# Review 2011 IEPR Transportation Energy Forecasts CEC Docket 11-IEP-1L

Jim Lyons  
Sierra Research, Inc.  
1801 J Street  
Sacramento, CA 95811  
September 15, 2011

**Figure 1**  
**Comparison of CEC FFV Population Forecast and CAFE Credits Available to FFVs**

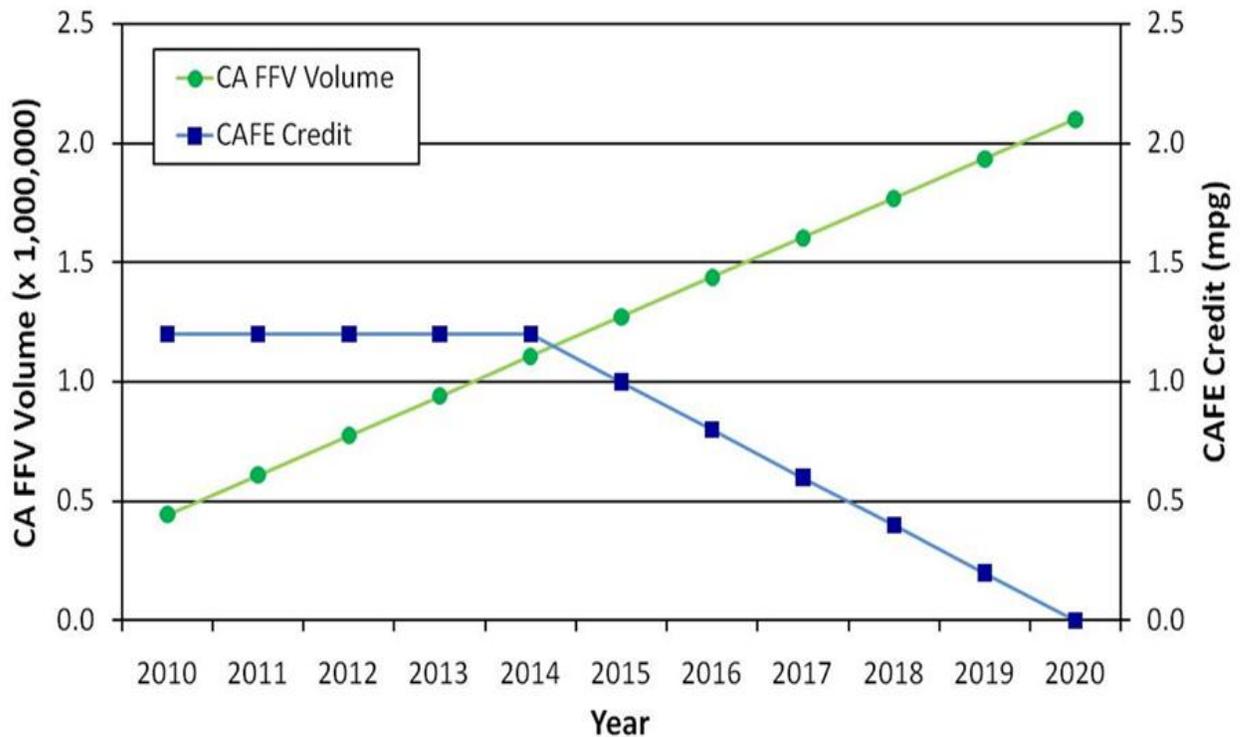
The third unsupported assumption is related to the CEC's forecast for increases in the number of flexible-fuel vehicles operating in California that are capable of operation on E85. As noted by CEC in Figure 14-4 and on pages 102 and 103 of the Draft Report, CEC currently estimates that there were 455,188 FFVs operating in California in 2010 and forecasts that this population will increase to 2.1 million vehicles by 2020 and 5.0 million vehicles by 2030. The assumed forecasts require addition of about 166,000 FFVs per year from 2010 to 2020, and by about 290,000 FFVs per year from 2020 to 2030. Actual growth in the California FFV population has occurred at far lower rates, with total California FFV populations of 200,000 vehicles reported in the 2003 IEPR,

250,000 vehicles reported in the 2005 IEPR, 382,000 in the 2009 IEPR and the aforementioned value of 455,188 FFVs in the 2011 IEPR. Furthermore, there is nothing to suggest that FFVs will be added to the California vehicle fleet at increasing rates in the future. The primary driving force behind FFV production has been the availability of federal CAFE credits for those vehicles. As shown in Figure 1, however, those credits will be eliminated at the same time CEC forecasts massive increases in California's FFV population.

In summary, the CEC ethanol forecast under the RFS2 relies on a number of unsupported assumptions that overstate the amount of E85 that is likely to be used in California while understating the cost of that E85, ignore the need for recovery of E85 infrastructure costs, and overestimate the number of FFVs likely to be available to use E85.

## CARB Forecasts for Vehicle Sales Under the ZEV Mandate<sup>4</sup>

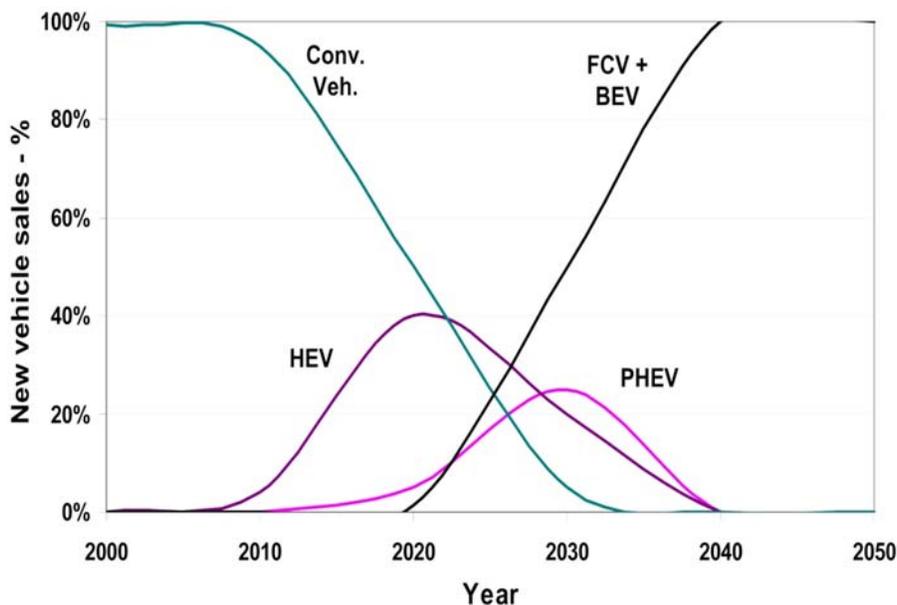
In addition, to what appear to be unrealistic vehicle population growth rates, it appears that there are a number of issues associated with the CEC’s forecast of PHEVs, full electric vehicles, and fuel cell vehicles. First, the CEC’s forecast is fundamentally at odds with the most recent CARB forecasts, which are presented below in Figure 2. As that figure shows, CARB projects far more demand for full electric and fuel cell vehicles than does CEC. This discrepancy is significant because full electric and fuel cell vehicles are expected to have far higher incremental costs than PHEVs (on page 189, CEC puts the cost of fuel cell vehicles at \$100,000), and will have fundamentally different needs with respect to refueling infrastructure.
